TITLE: PROPOSED DESIGN DEVELOPMENT OF TWO BLOCKS OF LATRINES EACH OF THREE UNITS

DRAWN BY	CHECKED BY
ENG. BIDHAAN	ENG. KAISE
DATE: JUNE 2024	SHEET 02

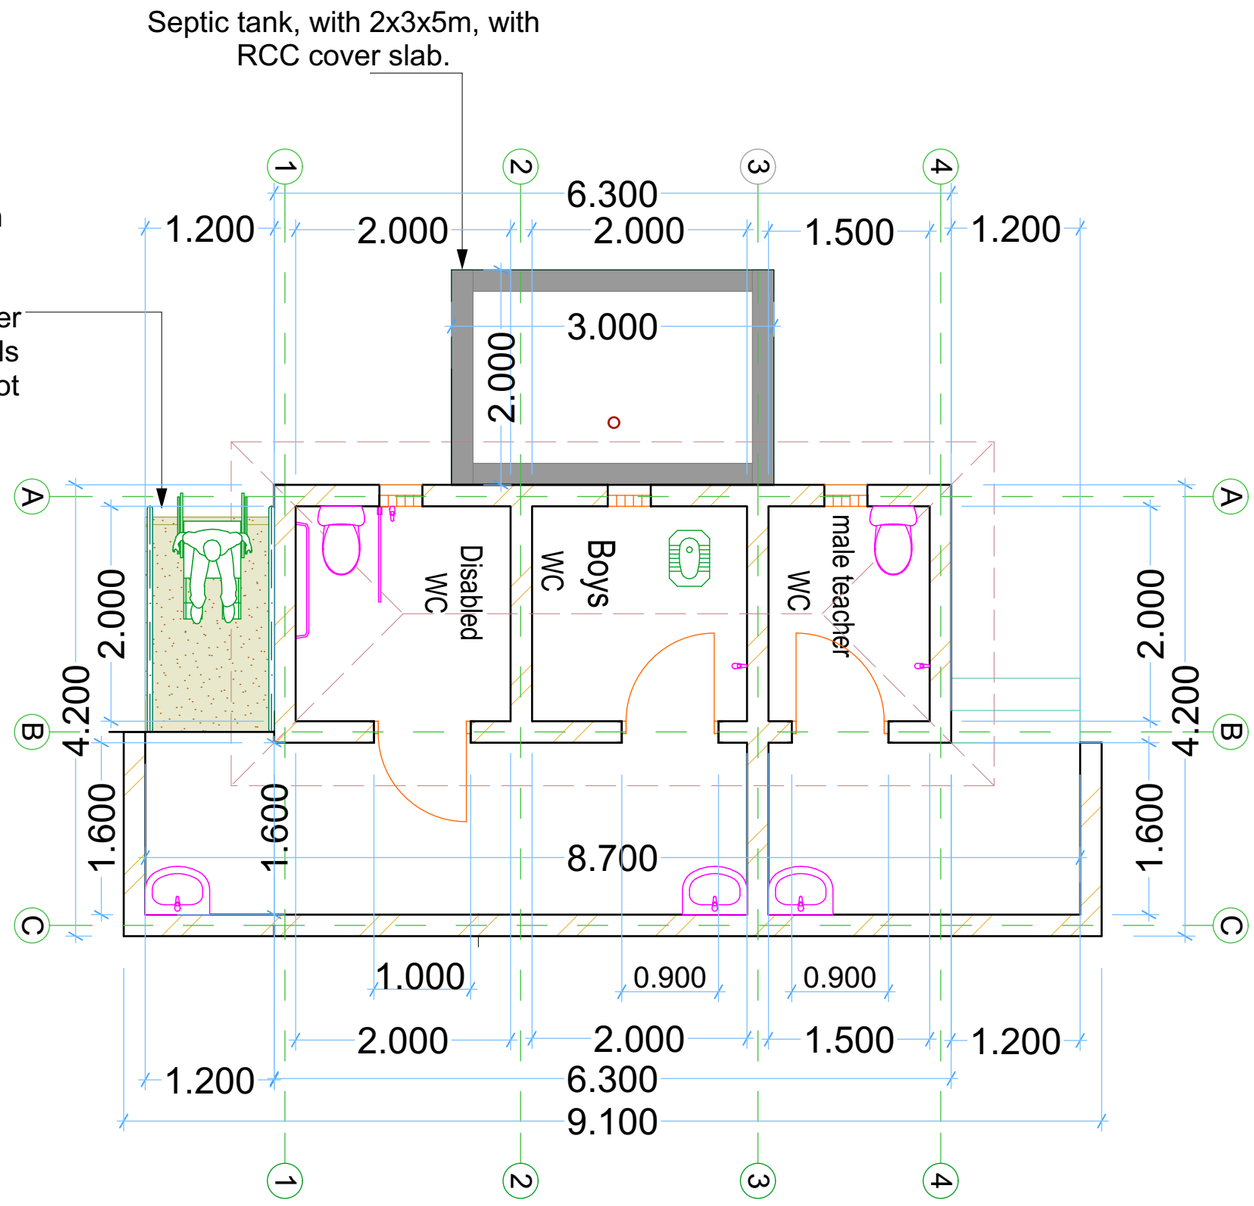
Ramp with Gentle slope with ration of 1:15; the dimension should be1.2m wide x 2m long and apply 8cm of concrete screed to the upper section of the ramp. install handrails both sides of the ram and height not mor than 90cm.
